Request for further information in accordance with section 92 of the Resource Management Act 1991

Notice of requirement: Eastern Busway EB2 (Auckland Transport)

Resource consents: Eastern Busway EB2
BUN60407133 LUC60407134 DIS60407135 (NES - FW)
DIS60407492 (Earthworks/Contamination)
CST60408360 (Occupation)
CST (Disturbance) – reference to be confirmed

Figure 5-11 Stream 2, Stream 3a and Stream 3b discharging into the Tāmaki Estuary at EB3R extent

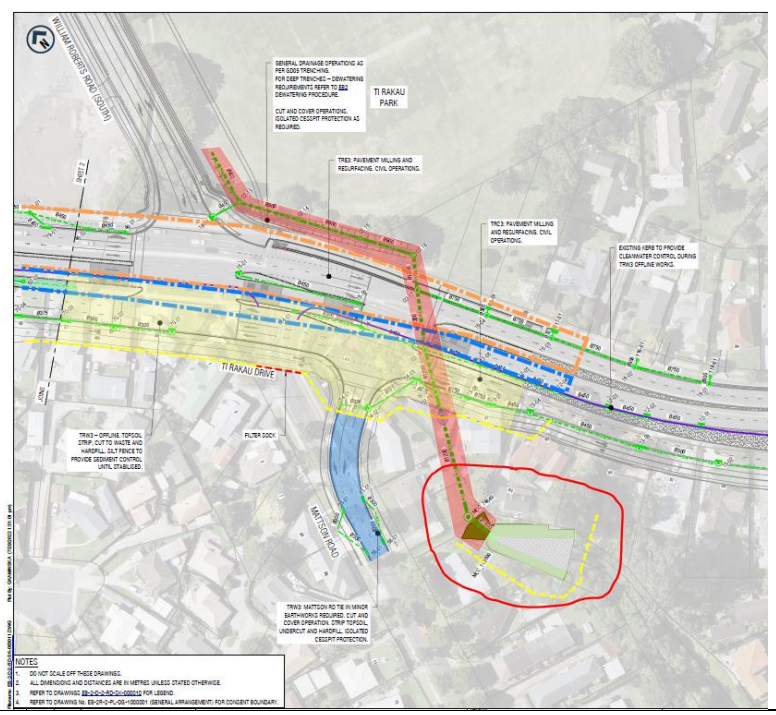
It is currently unclear whether consent under E3 would be required for the works associated with stormwater outfall and 'vegetated riprap' as shown on the ESCP drawings SK-000011 and SK-000012, which are located adjacent to or within 'streams 3a and 3b' as shown on figure 5-11 of the ecological effects assessment.

The drawings do not currently identify where the stormwater outfall construction is located in relation to the stream bed, or provide the dimensions of the structures.

It is currently unclear whether consent under E3 would be required for the works associated with stormwater outfalls and 'vegetated riprap' as shown on the ESCP drawings SK-000011 and SK-000012, SK-000012, which are located adjacent to or within 'streams 3a and 3b' as shown on figure 5-11 of the ecological effects assessment. The AEE and ecological effects assessment suggests that these works are a permitted activity, however, no further details are provided. The drawings do not currently identify where the stormwater outfall construction is location in relation to the stream bed, or provide the dimensions of the structures.

- a. Please locate the stream extent on the drawings to clarify whether works and/or structures will be located within the bed of a stream.
- b. Please provide the dimensions of the proposed structures located within the bed of the stream on the relevant drawings. (Dimensions of the existing structures would be helpful as a comparison to the proposed structures).
- c. Please confirm the total length of stream works proposed, as applicable.
- d. Please assess the proposed structures and works against the rules of chapter E3 of the AUP:OP and (regulations of the NES-F where applicable). Please either:
 - clarify how the structures / works will meet the permitted activity criteria; and/or
 - provide an assessment of effects where consent is triggered.

In each case, please clarify that the structure has been designed to occupy the minimum length / area of stream bed as possible.

Eastern Busway	Drawing Status FOR LODGEMENT	Design Package CIVIL AND GEOMETRICS
	Project Name 14200 0300 MOUNT SEEN CIRCUIT	Drawing Title TI RAKAU DRIVE EROSION CONTROL PLAN SHEET 5 OF 6
2016 NEW ZEALAND A1 1:500 A3 1:1000	Drawing Number EB-2-D-3-RD-SK-000014	Format A

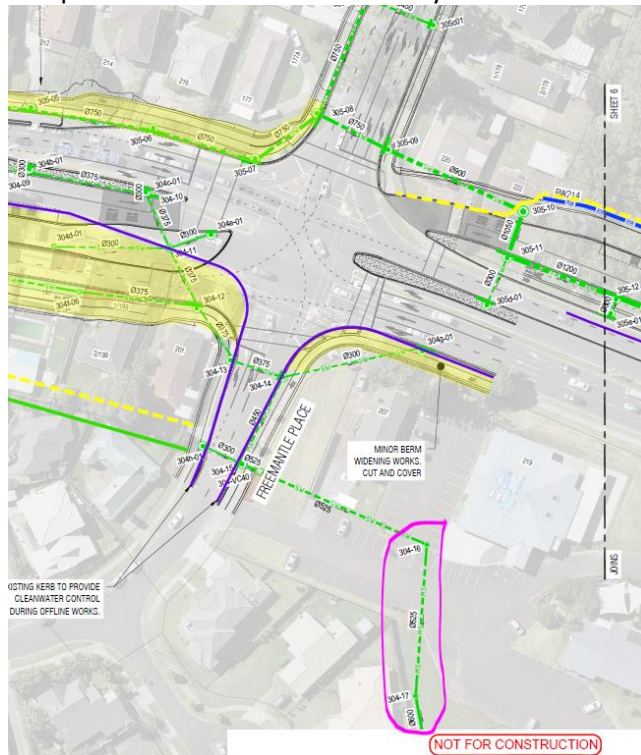
(112) ESCP Drawing SK-000014 identifies a stormwater line directed to the south of the drawing. For avoidance of doubt, please clarify whether this stormwater line(s) and/or outfall will be upgraded as part of the proposed development. Please update the drawings and provide details where necessary.

7 ESCP Drawing SK-000014 identifies a stormwater line directed to the south of the drawing (outlined in pink below). For avoidance of doubt, please clarify whether this stormwater line(s) and/or outfall will be upgraded as part of the proposed development. Please update the drawings and provide details where necessary.
